BMC Australia

# Bulletin

C1/69

MG  
MIDGET

## GEARBOX

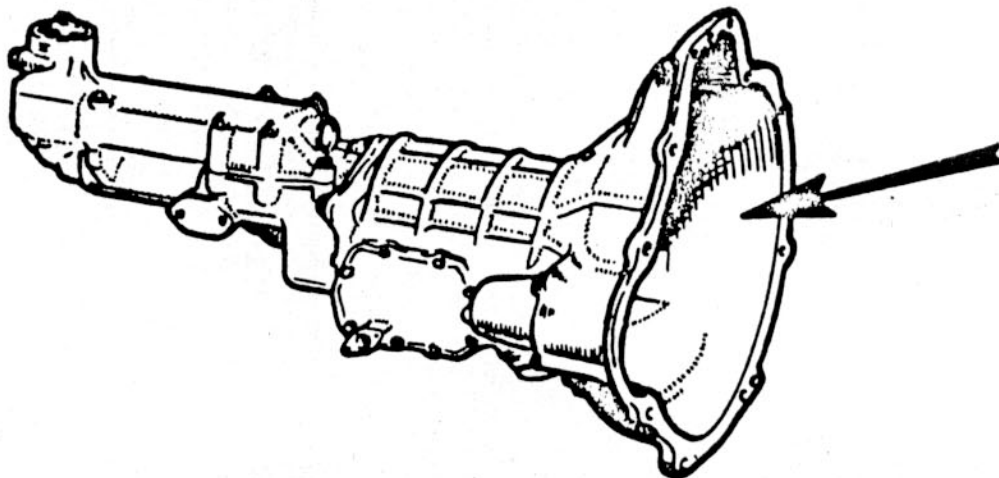
Difficulty in pulling up the gearbox to the engine may be due to the case assembly fouling the top left hand of the oil pump cover.

In such cases clearance should be given by removing a small amount of material from the inside of the casing where indicated by an arrow in the sketch.
